Tunxis Mead Park Expansion

Eastern Connecticut Environmental Review Team Report

Environmental Review Team Report

May 2000

Figure 4.

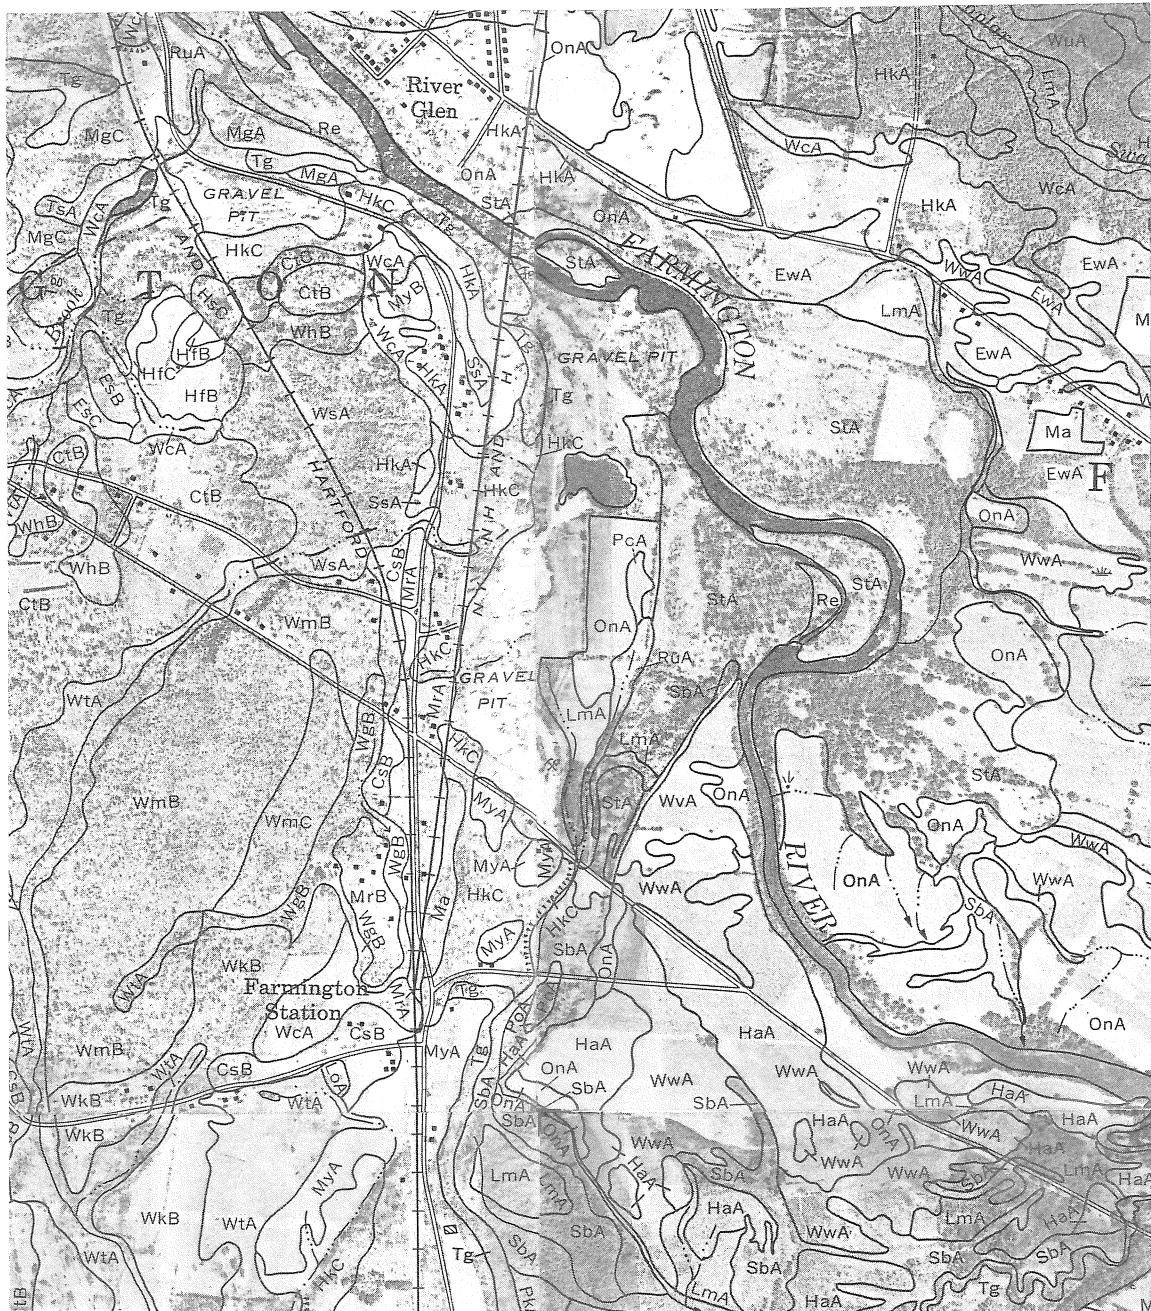
According to the USDA Soil Survey of Hartford County, 1962, most of the woodland contains Suncook loamy sand (StA), an excessively drained soil. The gravel pit area has been disturbed and now includes a pond and stockpiles of soil. A drainage swale diverts water away from the gravel pit area through the woodland and outlets into the pond. Other soils found in the parcel are Podunk sandy loam (PoA), Limerick silt loam (LmA), Ondawa sandy loam (OnA) Riverwash (Re), Rumney sandy loam (RuA), and Windsor loamy fine sand (WvA). Limerick and Podunk soils tend to experience frequent flooding with short durations in the winter and early spring. Rippowam soils tend to flood frequently with short durations from fall through spring and Suncook soils tend to flood frequently with brief durations in the spring time. Occum soils may flood occasionally and Windsor soils generally do not flood. See the soil tables and soil map for more details (Appendix A).

It is strongly recommended that the agricultural field be left in agricultural production. The soils within the agricultural field are prime farmland soils. Prime farmland is land best suited for producing food, feed, forage and fiber crops. Once the soil has been manipulated for other uses, its characteristics can change and it may no longer be prime farmland.

Figure 5.
Fema Map

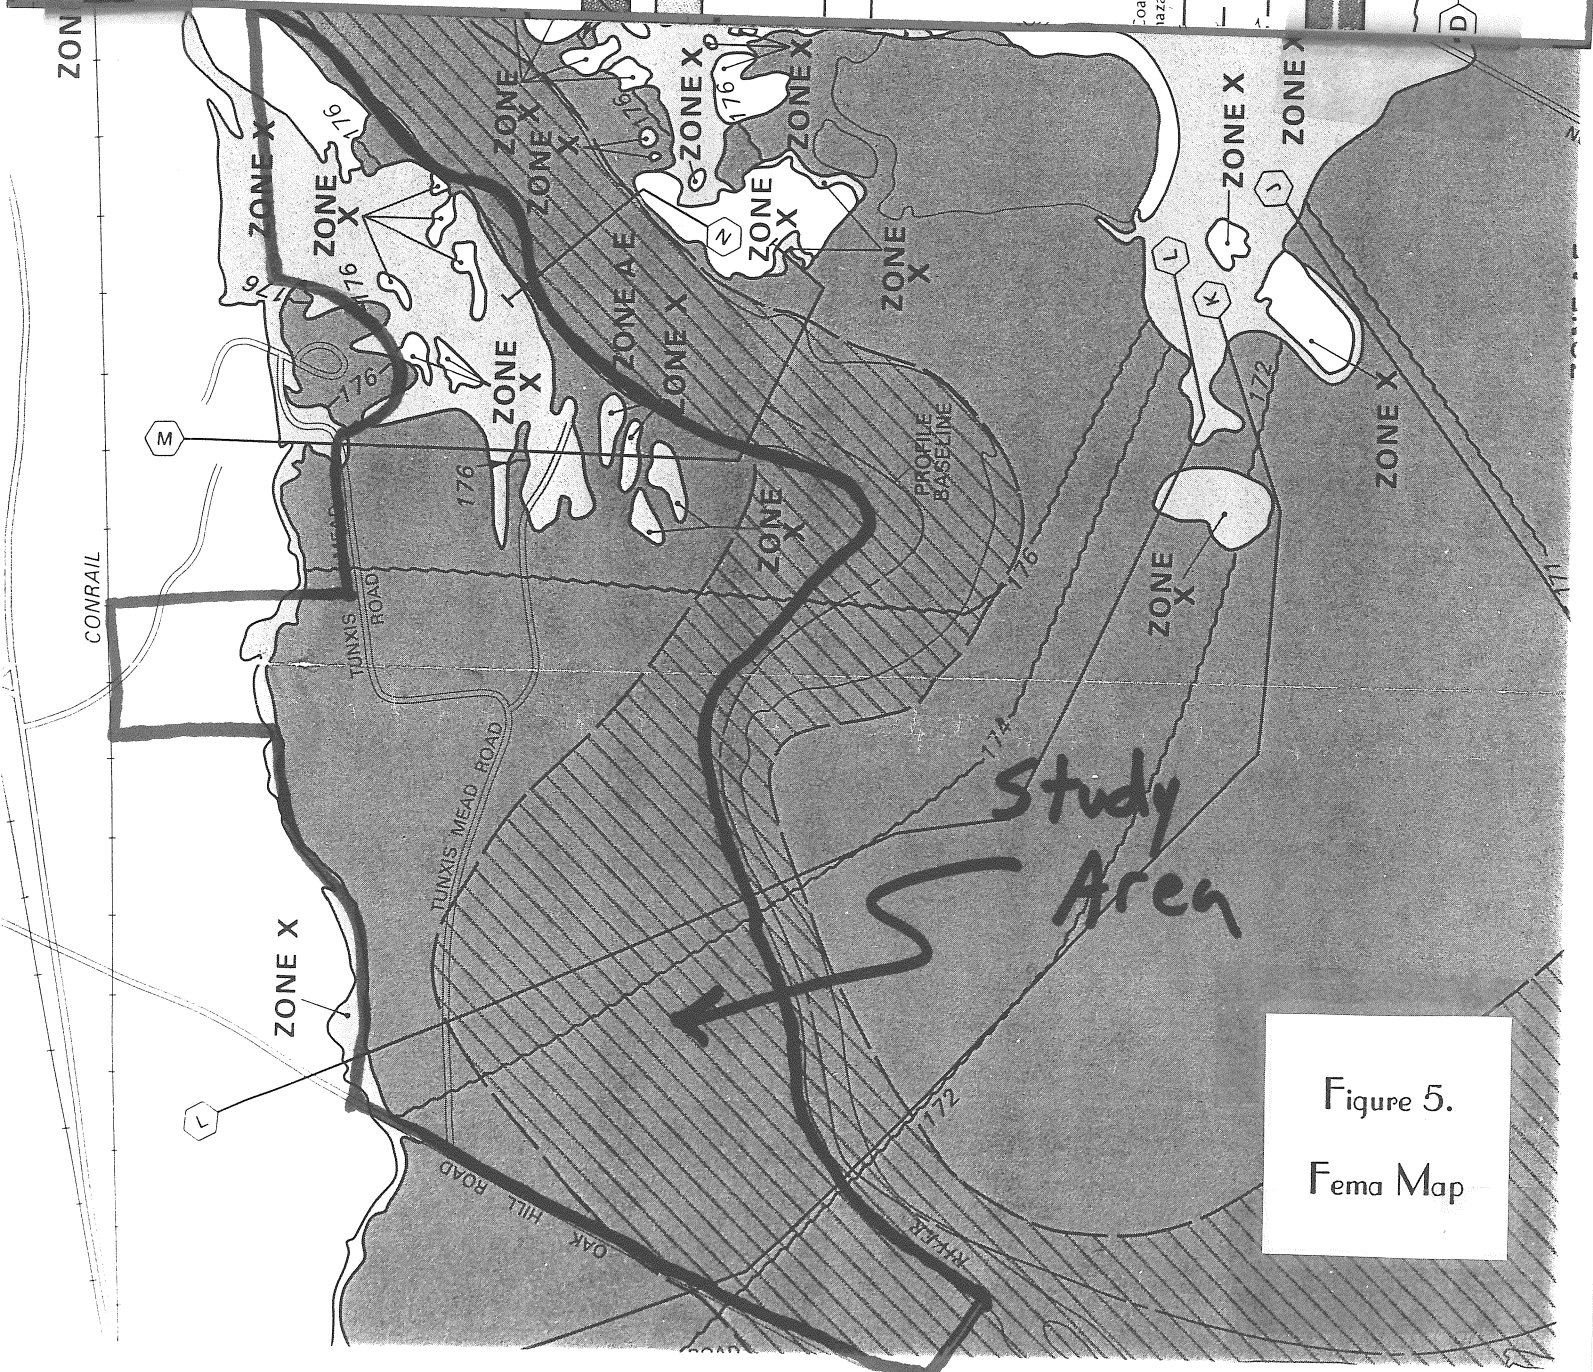
One of the critical functions of our floodplains is that of conveying flood waters during periods of high flow. While a majority of the study area exists within the 100-year floodplain as designated by the Federal Emergency Management Agency, a substantial portion of it has been designated as a more critical "Floodway" with velocities of

approximately 6.8 feet per second measured on site at cross-section "L" (see Figure 5). Development within a FEMA floodway, such as the placement of any material that may restrict or divert flood-flows is heavily restricted. During site walks, the Team wetland specialist saw no signs of high velocity flow on floodplain areas marked as "floodway", however, any planning for recreational facilities should be made with this in mind. It appears that some of the existing southern parking area exists within the mapped floodway. It is recommended that contingencies for dealing with high-velocity flood flows should be made for this facility.

Figure 6.
Vegetation Review Map

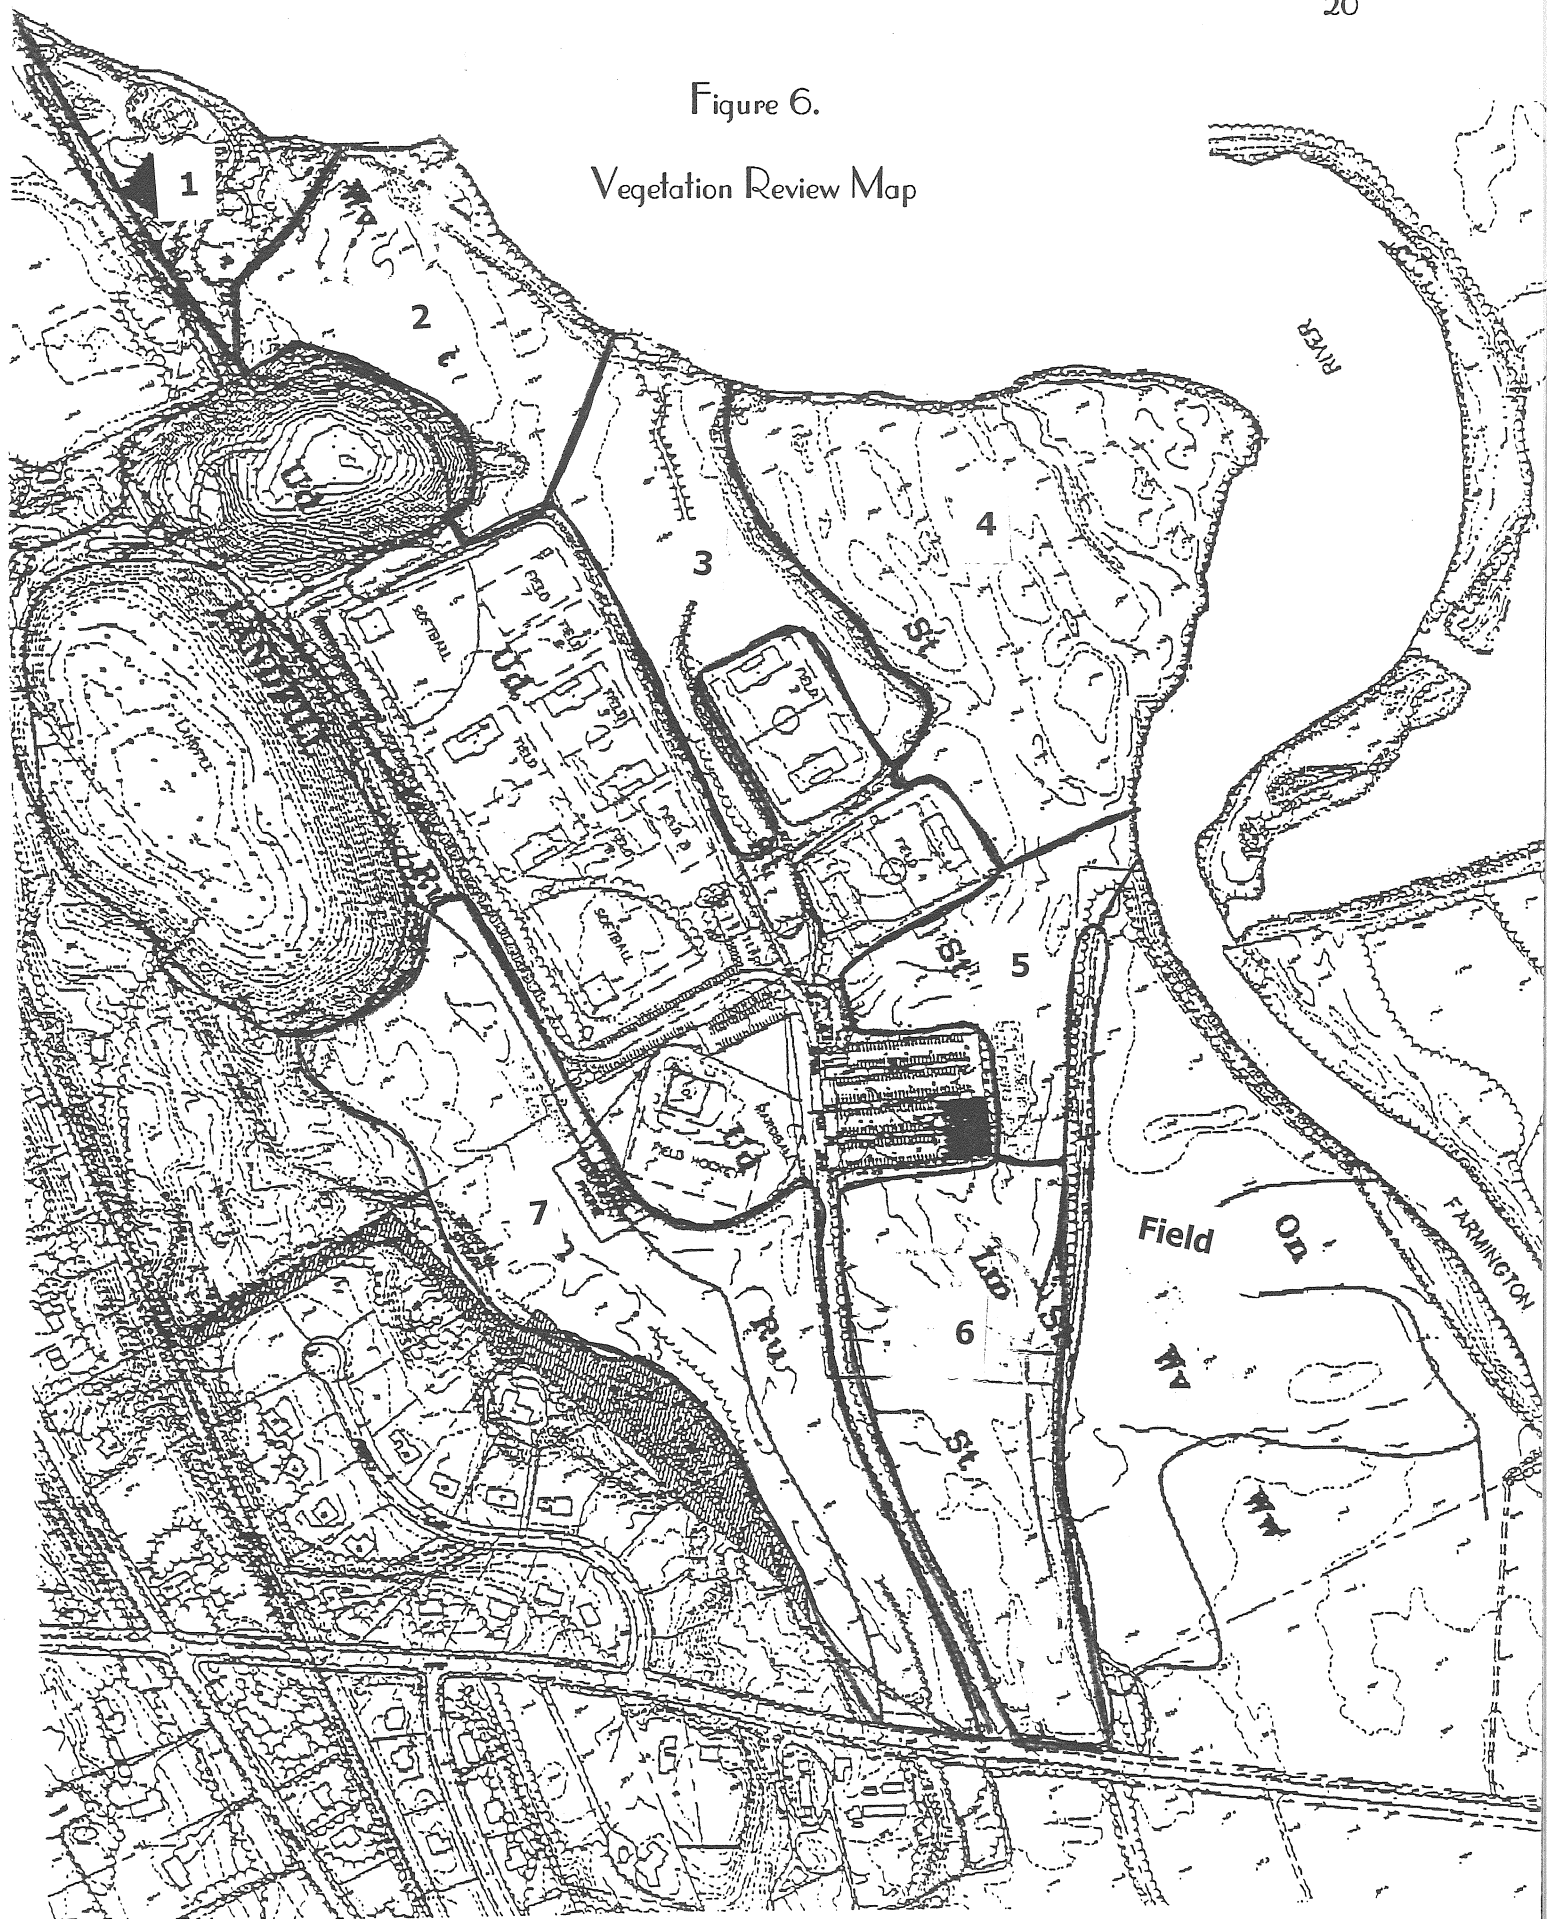
To help focus the comments and observations, it is useful to divide the wooded areas of the Park into various sections. For the purposes of this report, the wooded area of the Park will be divided into seven sections (see Figure 6), as follows:

The area of section one, while heavily disturbed and with little aesthetic appeal at present, does present opportunities for replanting. At present, there are very few conifers within the park. The planting of a mix of coniferous species, such as eastern white pine or white spruce, may be a means of reclaiming this area, both environmentally and aesthetically. Before any planting is done, the soil should be tested as to quality and characteristics.

Section two at present supports some recreational use, as evidenced by its trails. It is likely that this area could support additional recreational use without significant additional harm to the forest stand. That is said in part because of the amount of black locust and low quality black oak in the overstory, and Japanese barberry and Tartarian honeysuckle in the understory. The locust, barberry and honeysuckle are each considered to be invasive plants that will likely persist despite the increased disturbance that will likely result from greater use of this land.

If this section is used as a picnic area, the overstory trees will need to be assessed as to hazard potential. Picnic sites could be chosen so as to select for the removal of hazardous trees and invasive species.

Section three has two features that give it specific value. First, there are several young, healthy and well-formed red oak and sycamore trees within this section. These trees have the potential to be the basis for an attractive and long-lived forest stand. Given sufficient time, it might well be that that people will comment on how the "best trees" in the park are growing in this area.

Thus, in making decisions about the forestland in the park, the role of section two and section four, as riparian buffers, and the role of section four, as a relatively mature riparian forest ecosystem, should be given a great deal of consideration. Likewise, the role of section three as a protector of section four and as a stand that has a great deal of potential on its own, should be given importance. Finally, the less than ideal aesthetic characteristics of section six should not lead to the quality and properties of the trees in this stand being overlooked.
